**TN Americas LLC**

**Subject:** Supplement to Request for Revalidation of French Competent Authority Certificate F/410/B(U)-96 for the Model No. MANON Cask

## Response to RSI 1-1

Fig. 2: bremsstrahlung X-ray energy spectrum in lead target for a beta from Y-90.

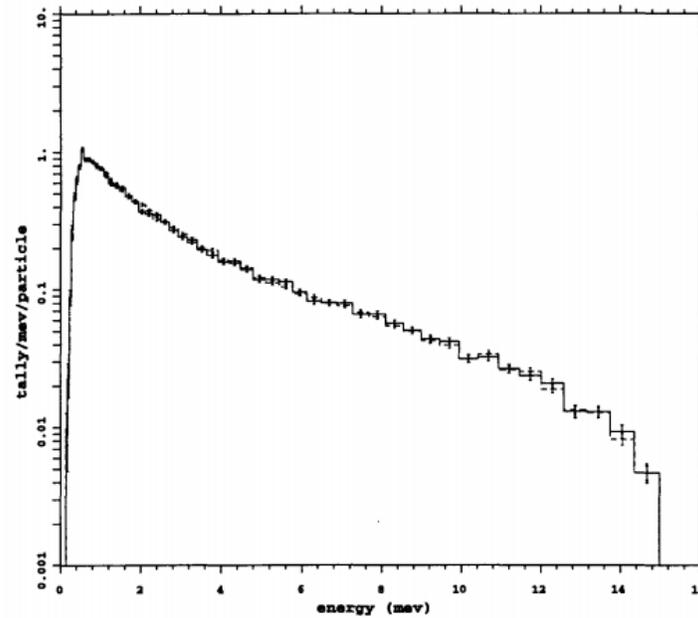
1. The bremsstrahlung source (i.e. energy spectrum and photons/sec).
2. Additional information on how the applicant generated the bremsstrahlung source. It is not clear from the statement above if it uses ORIGEN to do this or if it is evaluated using some other method. If it does use ORIGEN, the staff requests that the applicant provide the input file.
3. Materials and thicknesses of the packaging components credited within the shielding evaluation.
4. Drawing and tolerances for the credited components, with sufficient detail to justify the amount credited.

The X-ray spectrum is a superposition of a continuous bremsstrahlung spectrum and a characteristic K X-ray peak. Figure 2 shows the energy spectrum from a lead target.

Fig. 3: Geometry simulated of the Marguerite 20 source with the EDCE cask

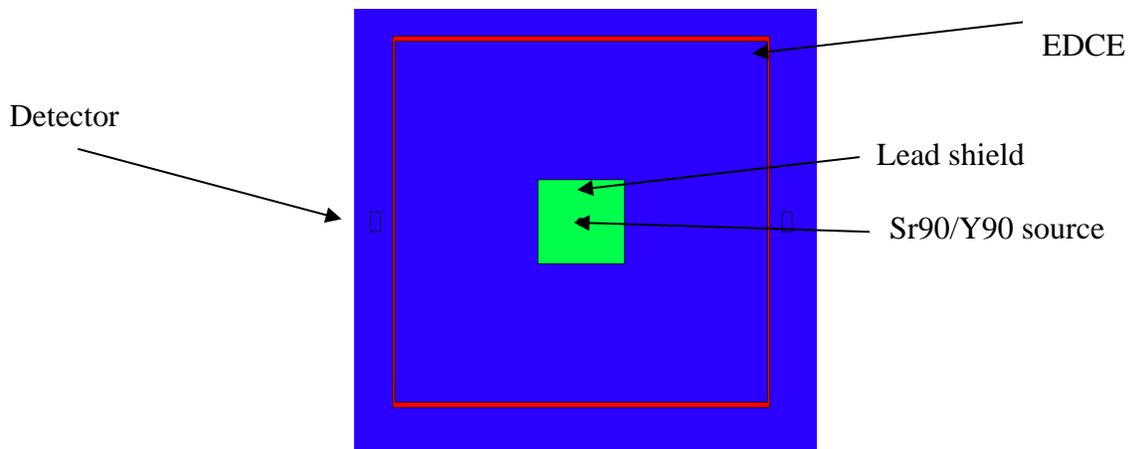
The staff does not have enough information on how the bremsstrahlung source was generated or how the package materials were credited to provide sufficient shielding for this source. The information in Section 5.3 in document U-8021-NT-01 Revision 1, page 11 credits enough material to attenuate the beta source, but this is not sufficient to appropriately shield the bremsstrahlung source.

The Sr-90/Y-90 source is shielded by a 18 cm lead cylinder. The shield is surrounded by a 1.5 mm thick stainless steel cask (with a radius of 73 cm). The dose rate is calculated at contact with the EDCE cask.
